Christchurch City Council | Shirley Road Options Considered Plan | Original Plan Size: A4 | ISSUE: 1 25/07/2017 | TP348503\_MJR\_CP502943

Christchurch City Council | Shirley Road Bus Stop The Palms Public Transport Facilities For Board Approval | Original Plan Size: A4 | ISSUE: 1 27/03/2018 | TP348501\_MJR\_CP502943

### BUILDING PROGRESSION AT SIS

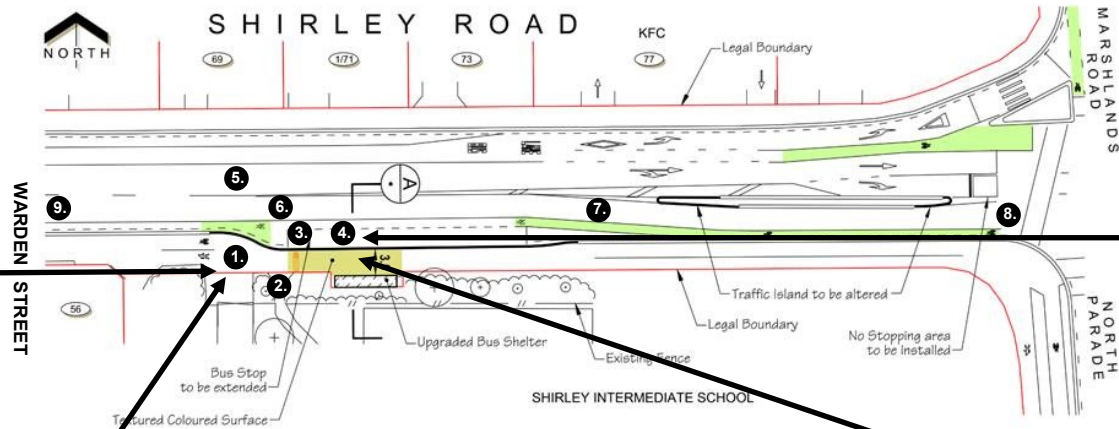
- 1. New SIS Two-Way Vehicle Access
- 2. Current SIS Footpath
- 3. New Shirley Road Bus Stop (2 buses)
- 4. Current Shirley Road Bus Stop (1 bus)
- 5. Issue: Waiting to turn right into 1.
- 6. Issue: Limited line of sight with 3. bus stop and first bus pulling out, no ability to see 1. SIS vehicle access if a bus is at 3. bus stop, drivers using 1. SIS vehicle access could be turning left or right, visibility of cyclists using the on road cycle lane.
- 7. Issue: Waiting to turn right into KFC.
- 8. Issue: Red Light Runners (a. drivers turning right from New Brighton Road to Marshland Road; b. drivers turning right from Marshland Road onto Shirley Road)
- 9. Issue: Warden Street (drivers turning left nearly get rear ended due to drivers being distracted/visually overwhelmed, some students are not aware on the busy environment/don't follow road rules/check before crossing the road.)
